AMENDMENT UNDER 37 CFR 1.116

USAN 10/033,775

AMENDMENTS TO THE DRAWINGS:

Annotated Sheet Showing Changes

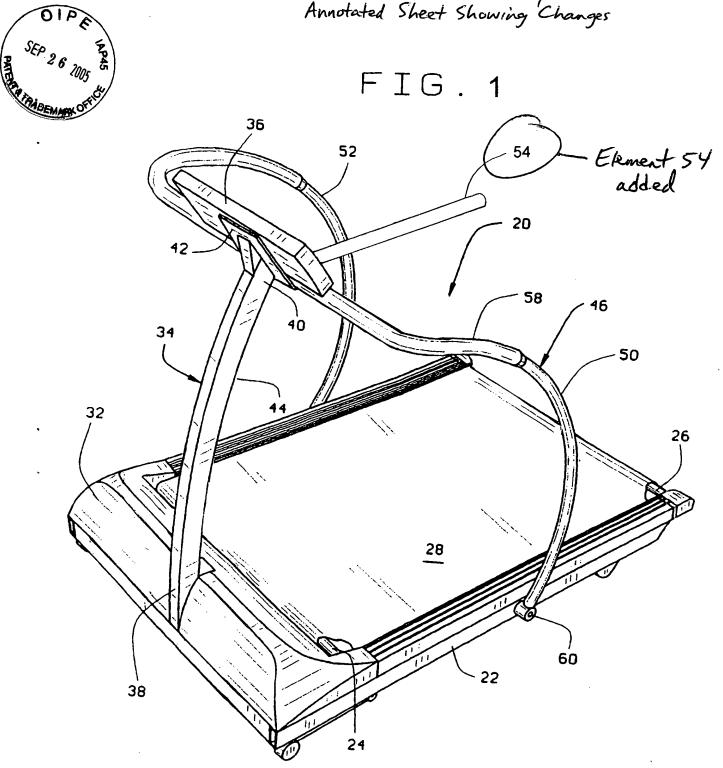
The attached sheets of drawings include changes to Figure 1 and a new figure

(Figure 2). These sheets replace the original sheet of drawings. In Figure 1, optional

element 54 has been added, and in Figure 2, another embodiment of the present invention

is shown.

In particular, the Examiner indicates that the two pairs of rollers and the pair of endless belts must be shown in the drawings or the features canceled from the claims.

Examiner requests that Applicants state on the record where the pair of endless belts and two pairs of rollers are shown in Figure 1.

In response to this objection, and to expedite allowance, Applicants submit herewith Fig. 2 showing the two pairs of rollers and the pair of endless belts. Fig. 2 is supported by the disclosure in the paragraph bridging pages 5-6 in the application.

However, to expedite allowance, Applicants have amended the drawings to show this embodiment in Figure 2. In this regard, Applicants note that the Figure 1 is directed to the broadly claimed invention as recited in claim 1.
